SERVICE MEMORANDUM
NO. SM0902

SUBJECT: WHEELCHAIR LIFT POWER CABLE ROUTING

MODEL YEAR: 2010

MODELS AFFECTED: VISIONS EQUIPPED WITH CUMMINS ENGINE AND WHEELCHAIR LIFT

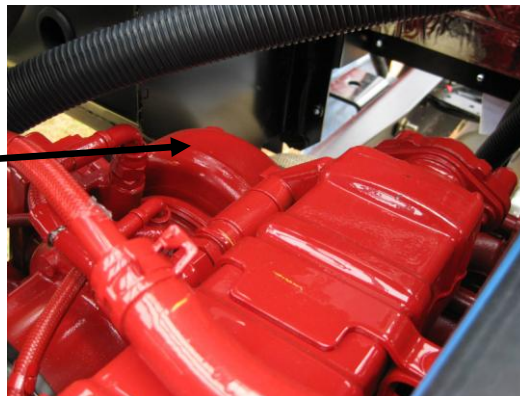
The wheelchair lift power cable may be routed too close to the engine exhaust manifold and/or turbocharger on 2010 model year “Vision” buses equipped with a Cummins engine and wheelchair lift delivered from May 29, 2009 through September 09, 2009. **These buses must be inspected immediately to ensure a minimum 6” clearance between the wheelchair lift power cable and engine exhaust manifold and turbocharger.**
